G30 (5 Series 540d xDrive)

SITUATION

CAUSE

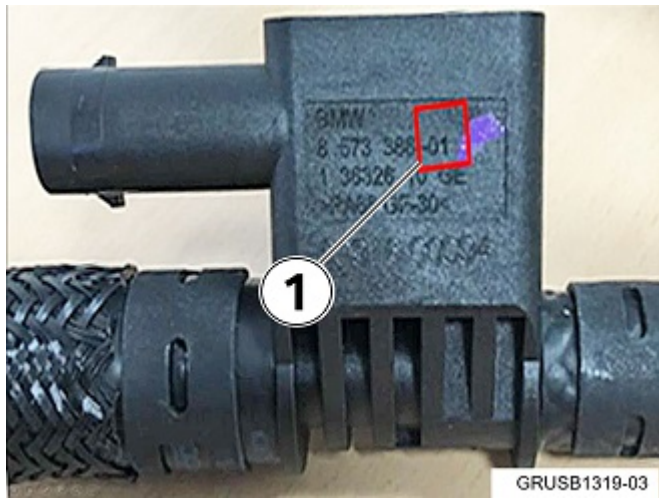
The improved fuel line can be determined by the change index (1) and part number located on the fuel temperature/pressure sensor of the fuel supply line.

Sensor part numbers with the improved fuel temperature/pressure sensor, and availability:

- 8 573 386 AI03 as of October 2018
- 8 573 385 AI02 as of January 2019
- 8 591 725 AI02 as of January 2019

Replace the fuel supply line in the engine compartment which contains the integrated fuel temperature/pressure sensor (PN 13 53 8 591 722).

The above mentioned part numbers for the pressure sensor cannot be ordered individually, as they are part of the fuel supply line (PN 13 53 8 591 722).
